SIL 659

Service Information Letter

Units Affected: AA/AN50, AA/AN55, AA/AN60, AA/AN67, AN46-OC, AN50-OC, AN55-OC, AM50, AM55, AM50E, AM55E, AM57, AM60, AM60E units built between June 2016 and December 2016 (see attached list).

Lower Control Valve Station Selector Improvement

Figure 1 — Electrohydraulic Valve

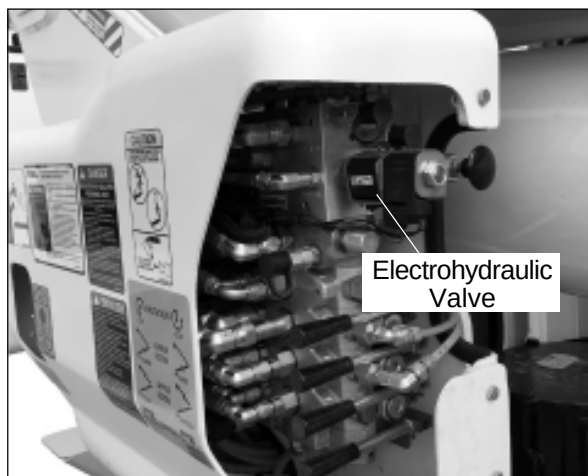
The affected units were manufactured with a manually actuated lower control station selector valve which must be held to engage lower controls. Altec has determined the manual selector valve can fail to shift or operate in some situations. As a result, a change has been made to replace the manual valve with an electrohydraulic valve. In addition, the secondary stowage switch is being relocated closer to the station selector so that one user can operate both functions.

Altec requires verification that the electrohydraulic valve has been installed no later than the next maintenance interval after the receipt of this SIL. Inspect the unit to verify that the lower control station selector valve has not been replaced with the electrohydraulic valve (refer to Figure 1). If the lower control station selector valve has been replaced with the electrohydraulic valve, no further action needs to be done and the SIL is complete. If the original manual valve is still on the lower control valve (refer to Figure 2), it must be replaced.

Altec has created a kit for this improvement. Call 1-877-GO ALTEC (1-877-462-5832) to order the correct kit for the unit using the chart below.
